FINAL
MONITORING REPORT (MY1)

SLINGSHOT MITIGATION SITE
Rockingham County, North Carolina

DMS Project ID No. 100058
Full Delivery Contract No. 7525
USACE Action ID No.SAW-2018-01170
DWR #20180795 RFP No. 16-007330

NCDMS Comment Responses:

Figure 2. Current Conditions Plan View
Tables 5A-5C. Visual Stream Morphology Stability Assessment
Table 6. Vegetation Condition Assessment
Vegetation Plot Photographs

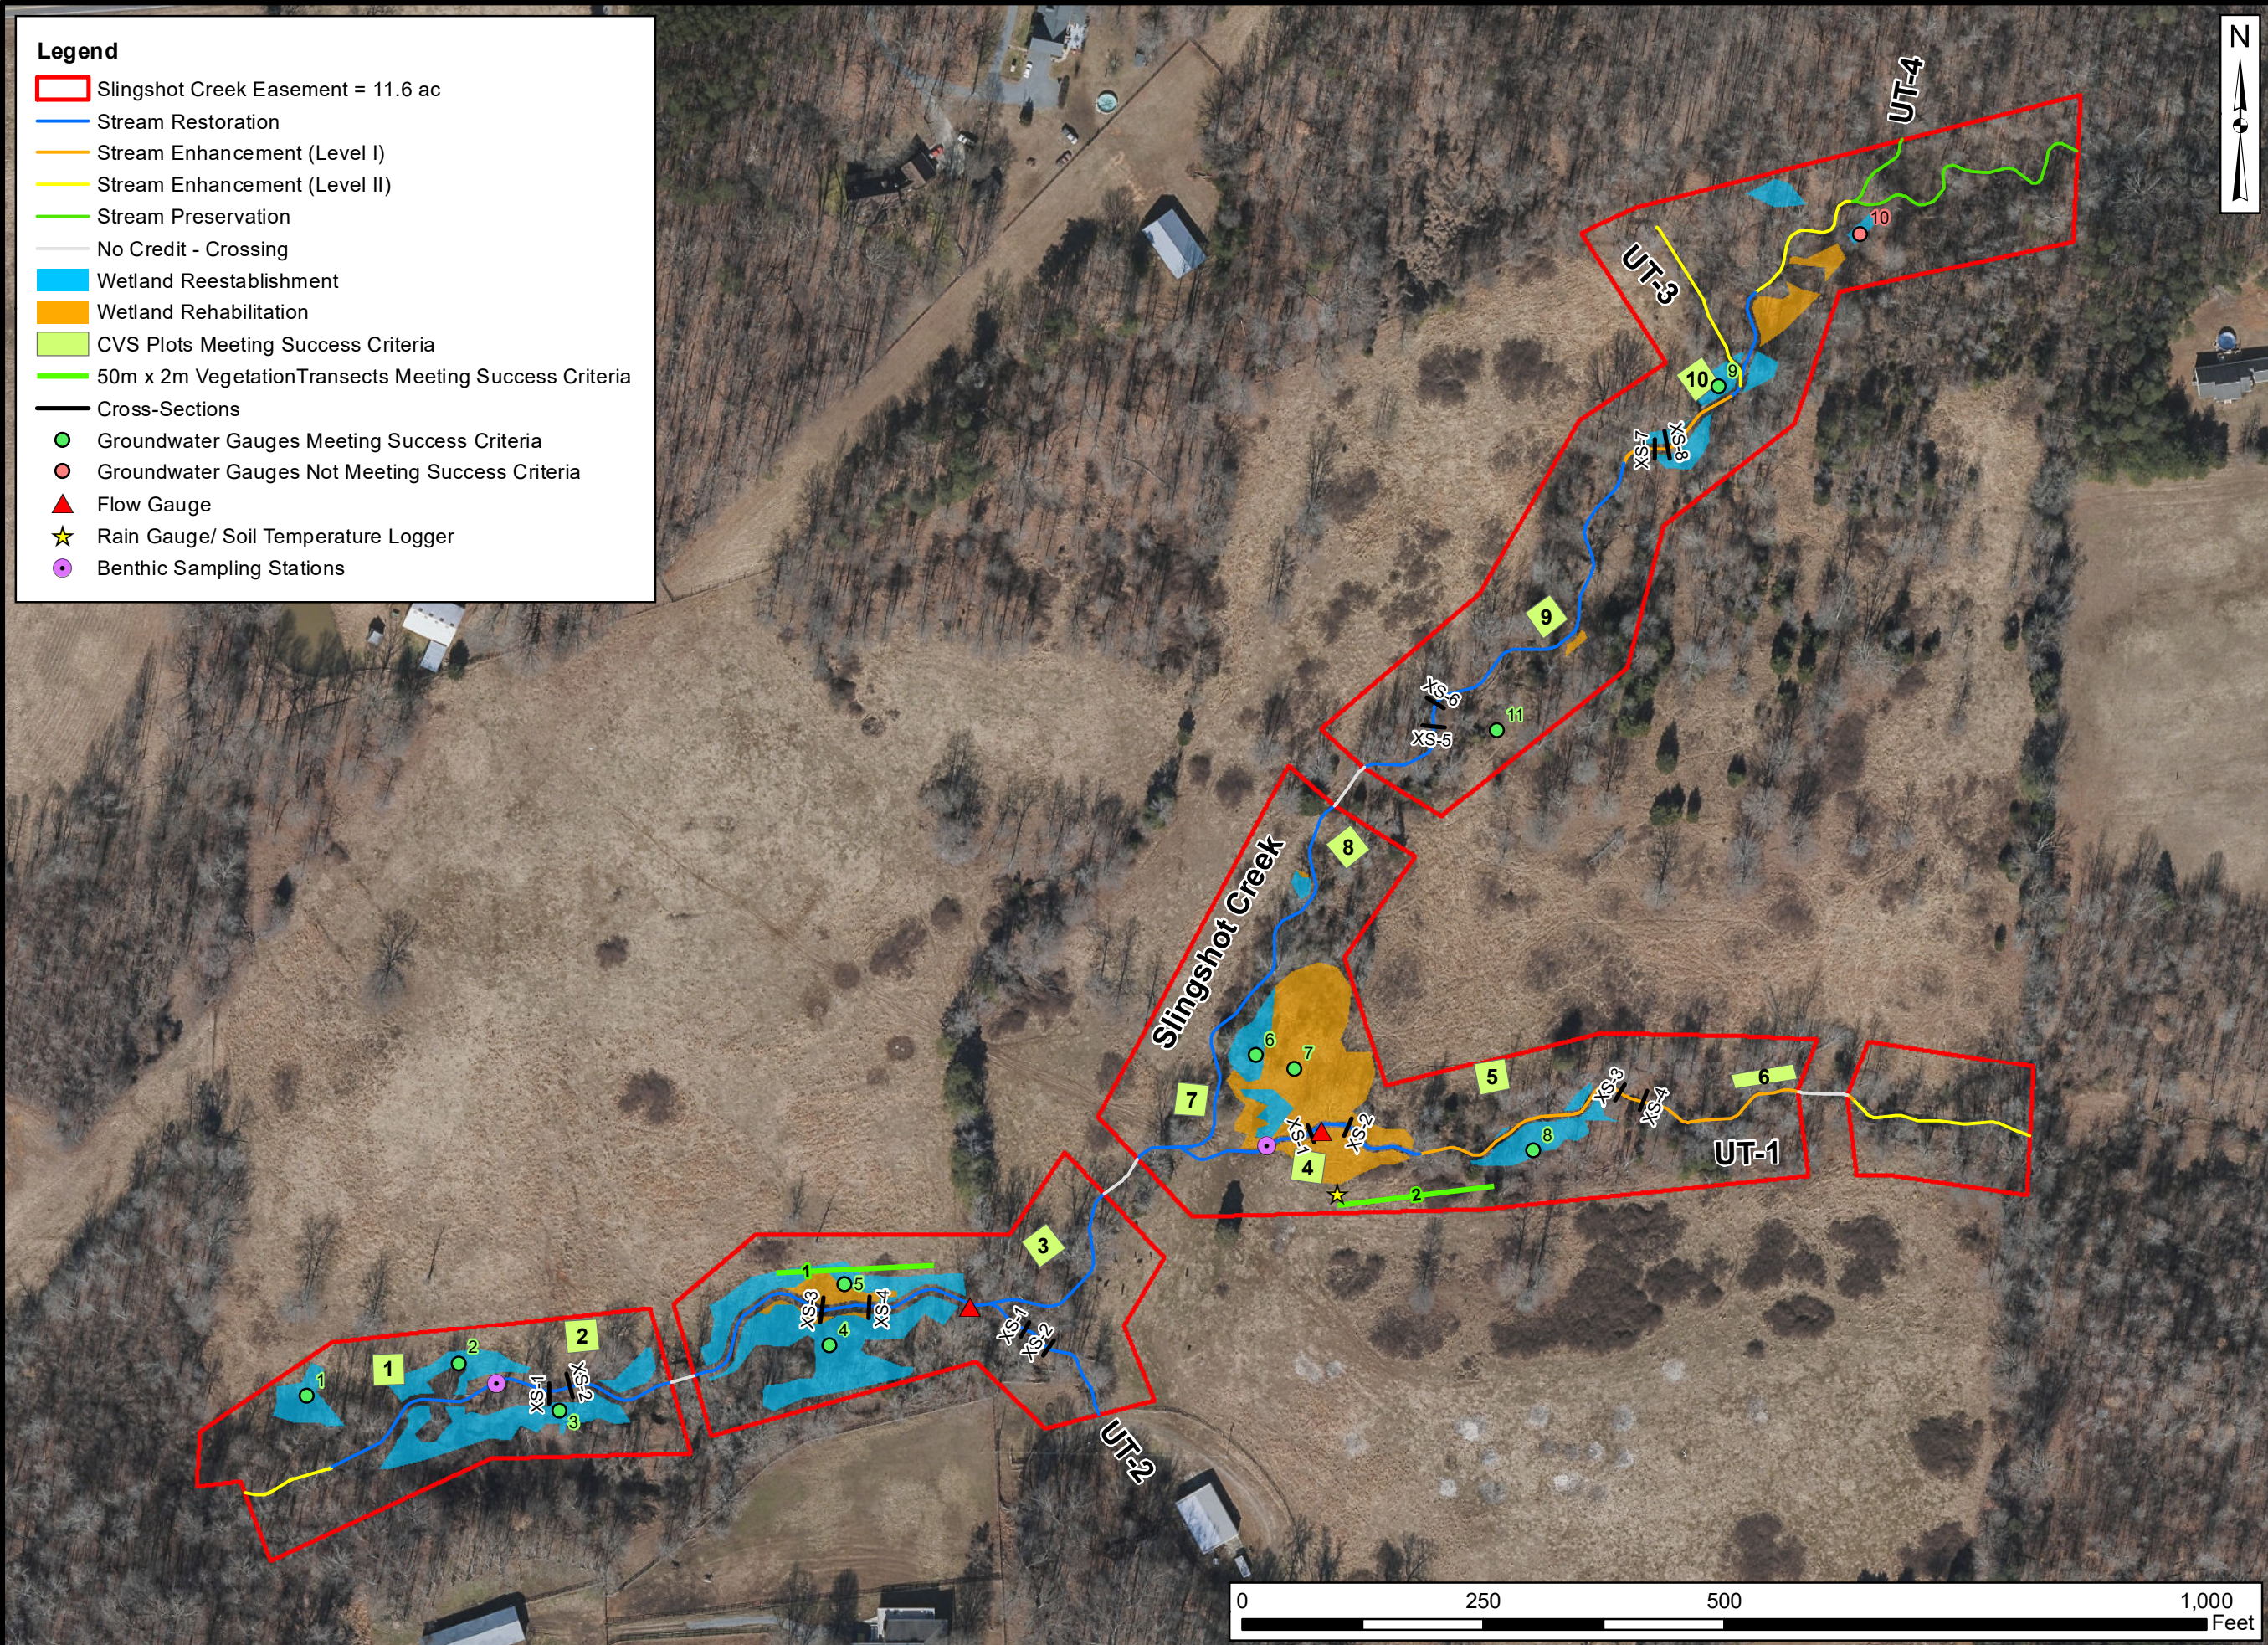
2. Appendix B – Please include a feature depicting the 40 ft. of bank erosion in the CCPV (Figure 2), and include this feature in the digital submittal.
The bank erosion in Table 5 was misidentified by field personnel and mistakenly included in the draft Y1 Report. It has been removed from the document. All site reaches are stable and there are no areas of concern.

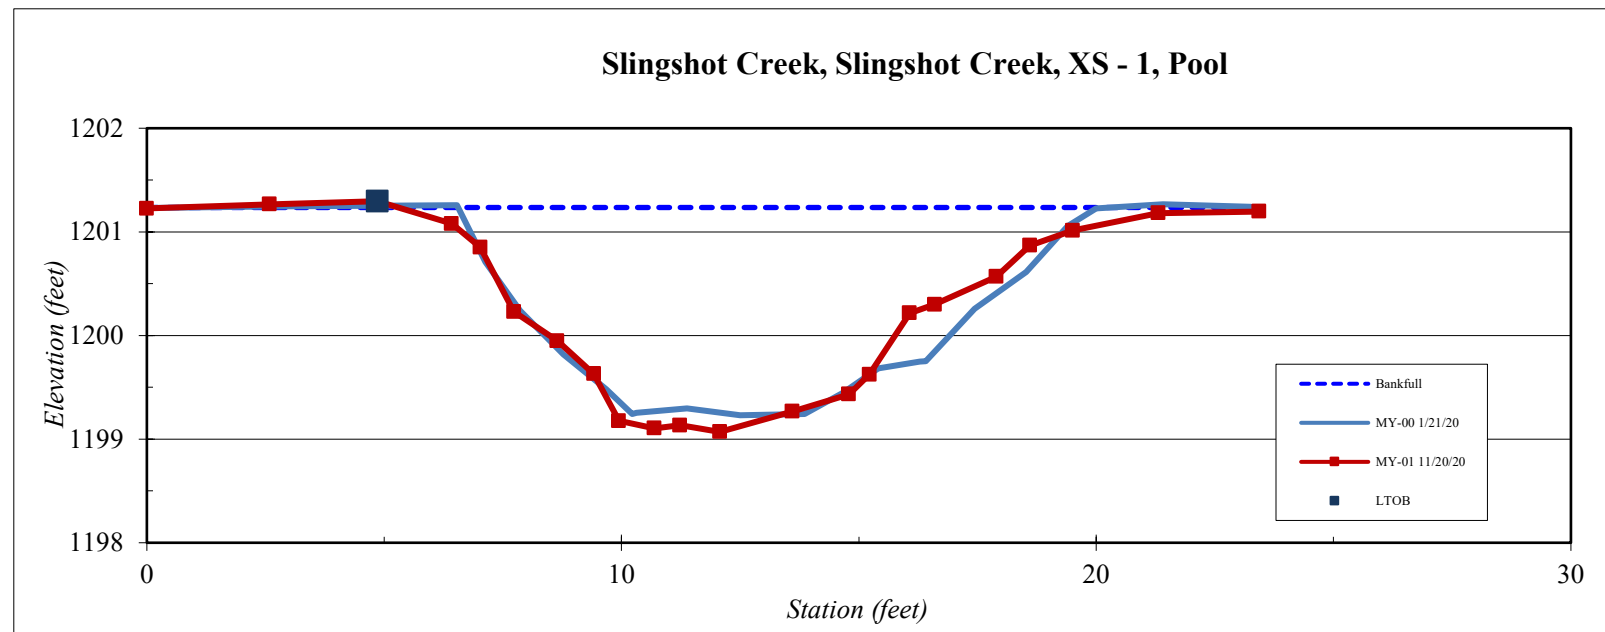
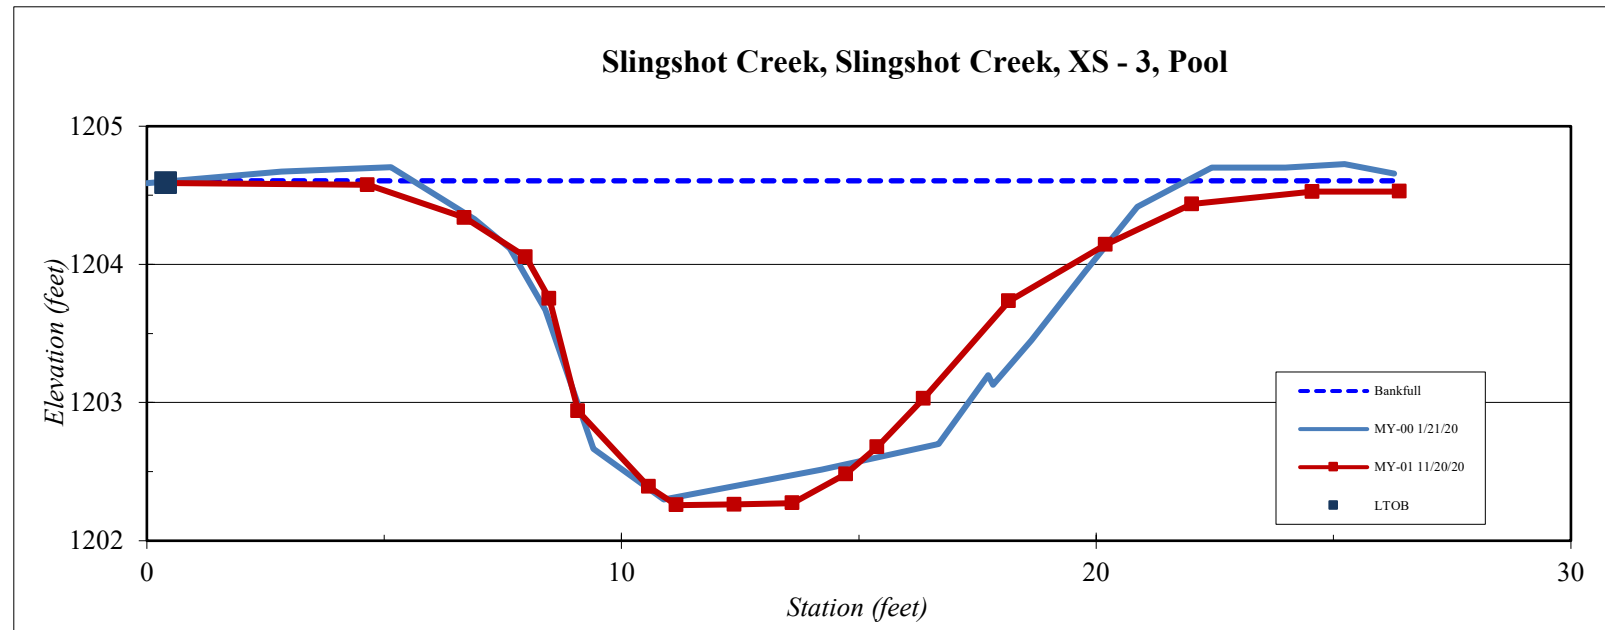
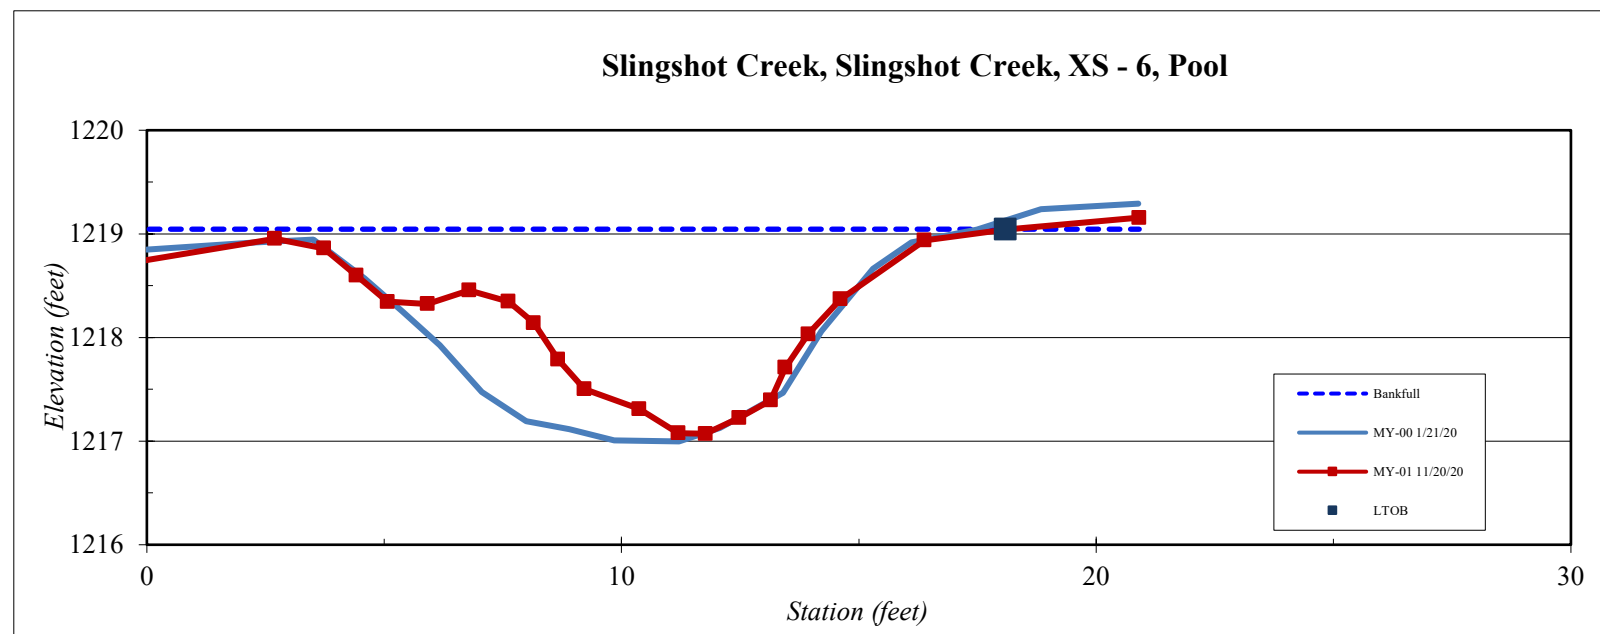
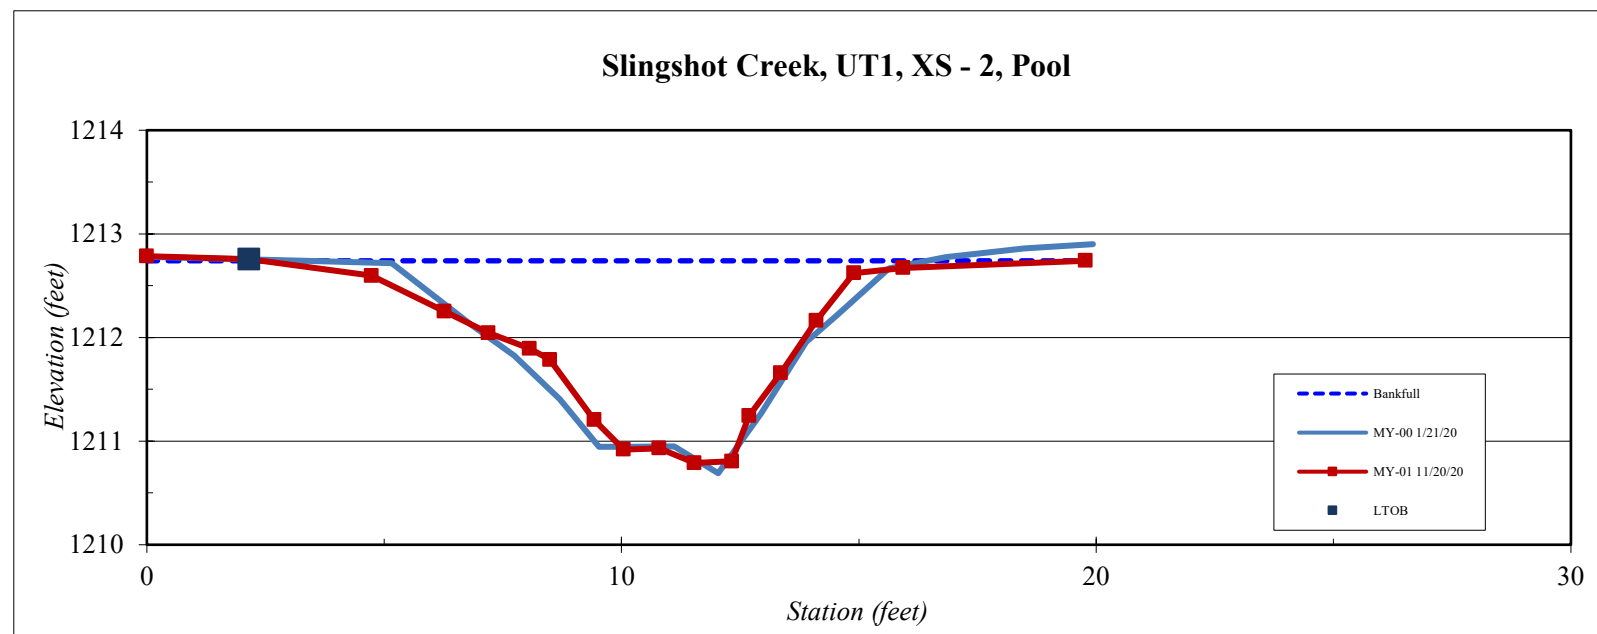
- c. Cross Sections – We recommend entering N/A for BHR in the Summary Data tables for pool features. Also, we recommend removing the MY-00 TOB line (green, dashed line) from the cross sections. Only need to show (calculated) bankfull and LTOB.
BHR calculations were removed from pool cross-section reports, and the MY-00 TOB lines were removed from all cross-section plots.
